Quality Assurance of Chapter 11: Requirements on Upper Shelf Energy

This report documents the results of the quality assurance (QA) task for Chapter 11 of the draft technical basis NUREG for the risk-informed Appendix G project. Chapter 11 discusses the derivation of updated minimum upper shelf energy (USE) requirements for reactor vessels. The quality assurance effort for this chapter involved three specific subtasks: (1) confirming the validity of stress intensity factor equations used in Regulatory Guide (RG) 1.161, (2) verifying calculations of minimum USE based upon the RG 1.161 methodology, (2) verifying Fracture Analysis of Vessels-Oak Ridge (FAVOR) runs used to calculate minimum USE.

Figure 6: Required USE calculated according to RG 1.161 for (a) TB work and (b) QA work.

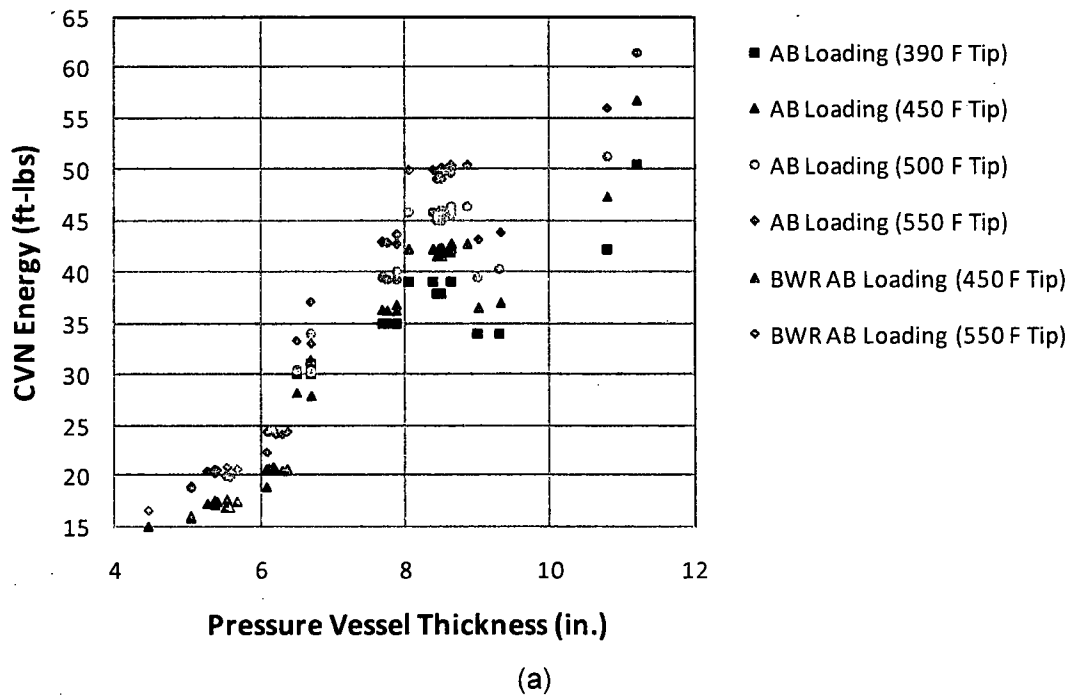
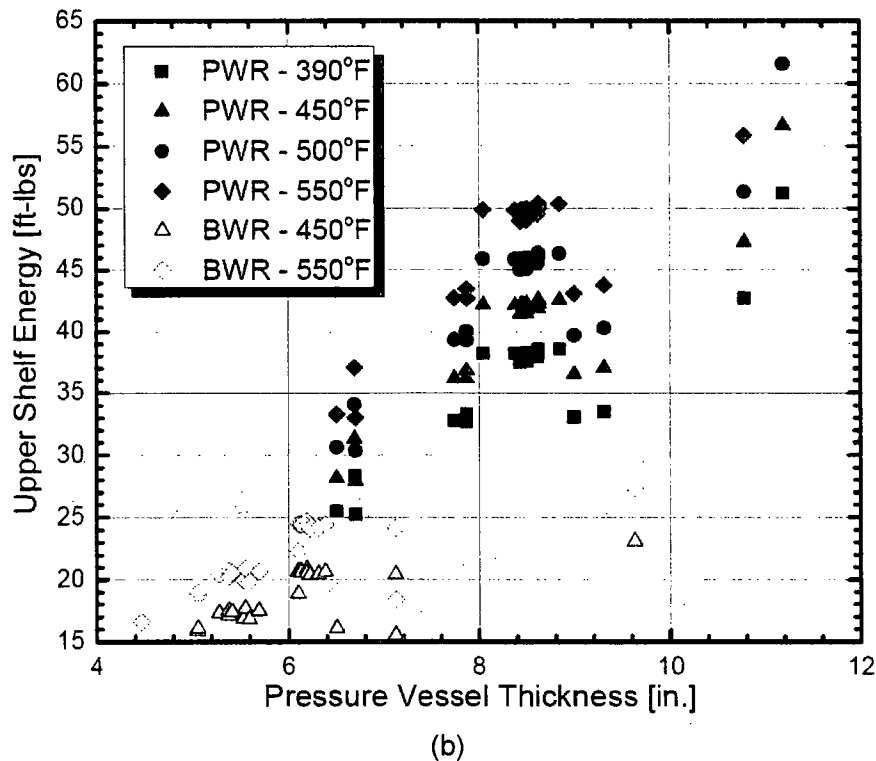
The interviews revealed one issue of concern for the RG 1.161 calculations: the crack stability criterion (Equation 2) was not employed in the TB work. As a matter of technical rigor, the crack stability criterion should always be included in the calculations, since the safety factor for that criterion is higher than that for the non-initiation criterion (Equation 1). The results of these calculations from the TB work and QA work are compared in Figure 6 (a) and (b), respectively.

The results from the QA work (which accounted for crack stability) compare well with the results from the TB work, demonstrating the fact that the non-initiation criterion plays a dominant role in determining required USE. The issue raised by the QA work, therefore, has little effect on the results of this calculation.

2. While the TB work incorrectly neglected the crack stability criterion for the RG 1.161 calculations, modifying the analysis to account for crack stability does not change the results of the analysis.

Figure 3: Comparison of required USE obtained from the RG 1.161 and FAVOR methods for (a) the TB work and (b) the QA work.

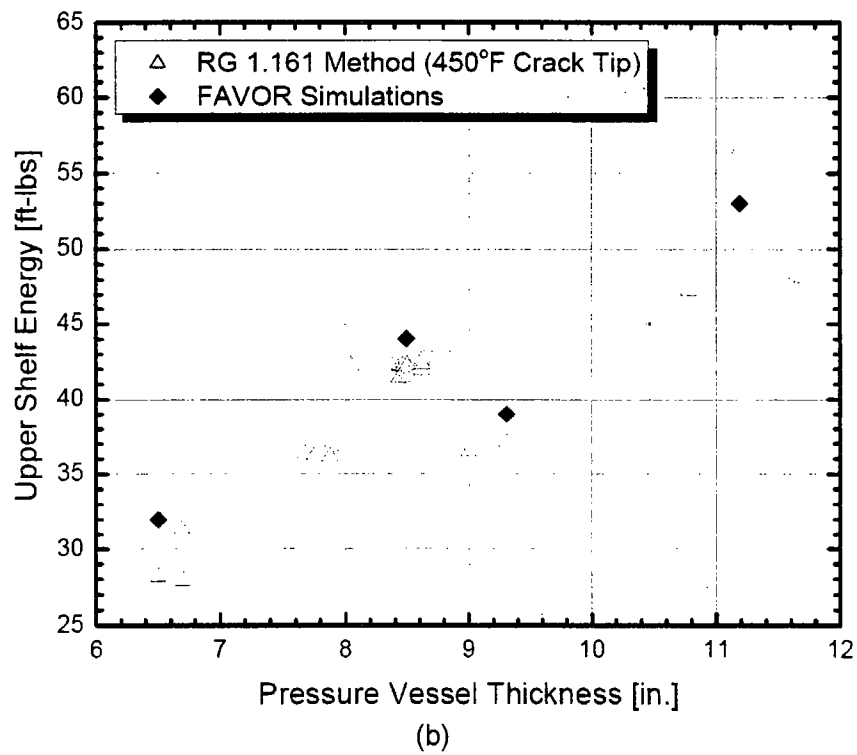
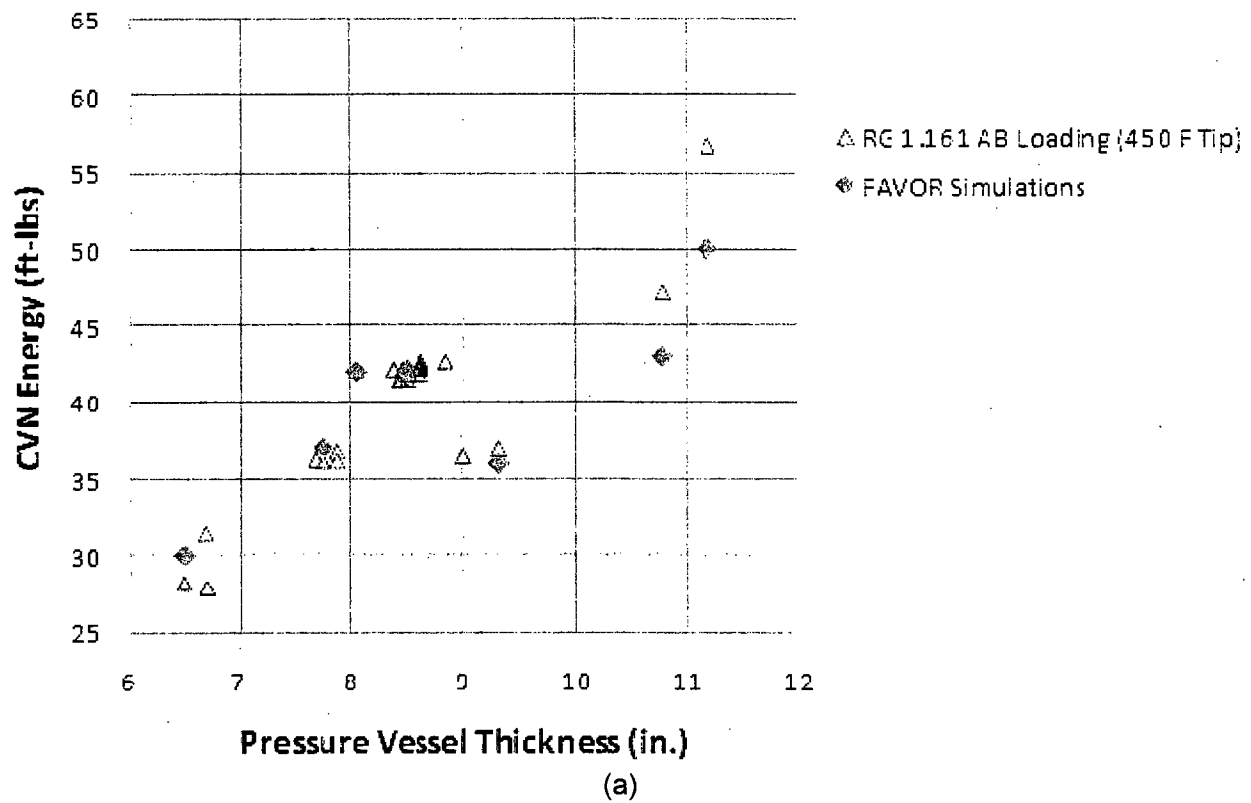
The QA calculations included a factor of 1.09 in the applied J calculation, in order to account for the small scale yielding correction. For the purposes of calculating required USE, this procedure is not recommended. For the purposes of the QA work, however, it provides a method to assess the error introduced by neglecting the small scale yielding correction. A comparison of Figures 3 (a) and (b) shows that the required USE is increased by roughly 3 ft-lbs when accounting for small scale yielding. The main conclusion of the TB regarding this work (i.e., that 450°F is the correct temperature input to J_R model) remains valid, since the results of the FAVOR simulations match closely with the results of the RG 1.161 calculation.

3. The proposed procedure to calculate J from FAVOR results neglects the small-scale yielding correction (Equation 7), which can increase the calculated J by 9%.

4. After adjusting the calculated J results by a factor of 1.09 to account for small scale yielding, the results still confirm the original conclusion from the draft TB: 450°F is an appropriate crack tip temperature to use for the RG 1.161 calculations.

Figure 5: Figure reference in draft TB to demonstrate a situation where the crack stability criterion is violated.

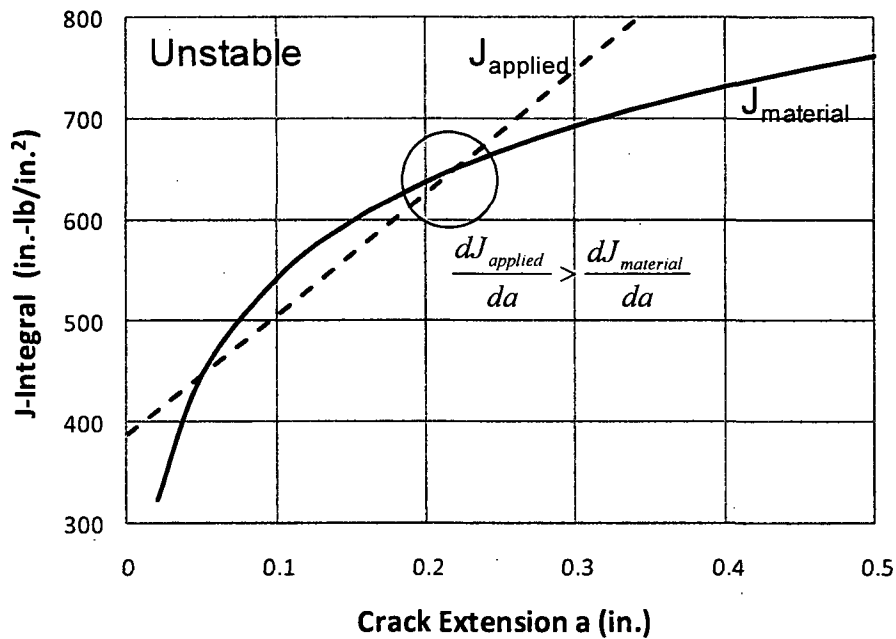
The draft TB for the minimum USE shows Figure 5 to demonstrate a situation where the crack stability criterion is not met.

In fact, Figure 5 illustrates a situation that meets the crack stability criterion, since there is a portion of the driving force curve (i.e., applied J) that lies below the resistance curve (i.e., J_{material} in the figure, or J_R). While the slope of J is indeed greater than the slope of J_R at the point circled, the correct intersection point to perform this evaluation is the one located at lower crack extension. This concept can be confirmed by considering a figure from a fracture mechanics text (Figure 6).

5. Figure 5 should not be included in the TB to demonstrate instability, since it actually demonstrates stability.
6. The proposed thickness-dependent USE limit was independently verified by the QA work.

Figure 6: Demonstration of crack stability.

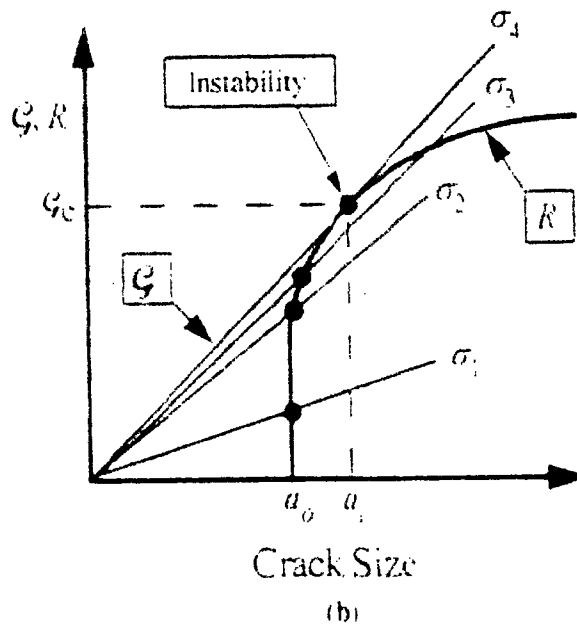
Figure 6 shows that instability begins when the driving force curve is tangent to the resistance curve. When the driving force curve is secant to the resistance curve, the crack is stable.
